PHILIPS-HORNY
Service-Zentrale
ARCHIV
Information

REEL TO REEL RECORDER
N4520

A80-101

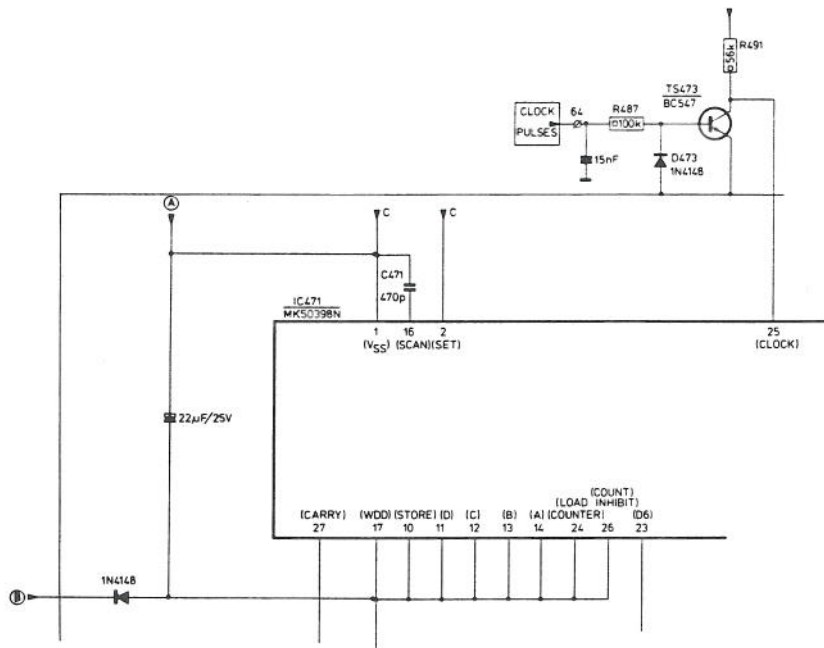
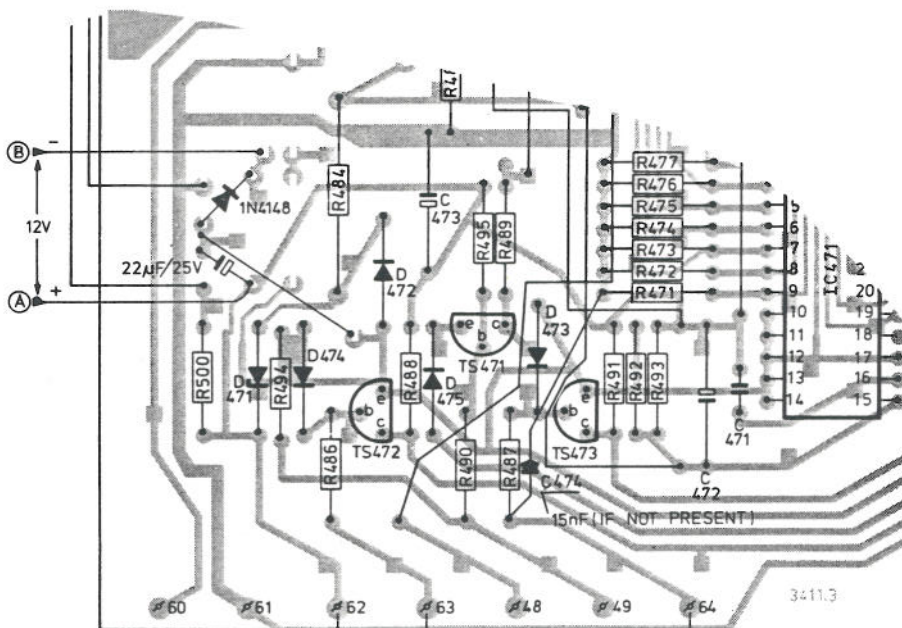
7. In order to prevent the counter information from disappearing when switching off the mains switch, the components indicated in red can be added.

When the mains switch is switched off, the position of the counter remains constant, even after displacing the counter roller.

Use a voltage source with the following specifications:

Output voltage : 12 V ± 1 V stabilized
Current : Minimum 40 mA continuous
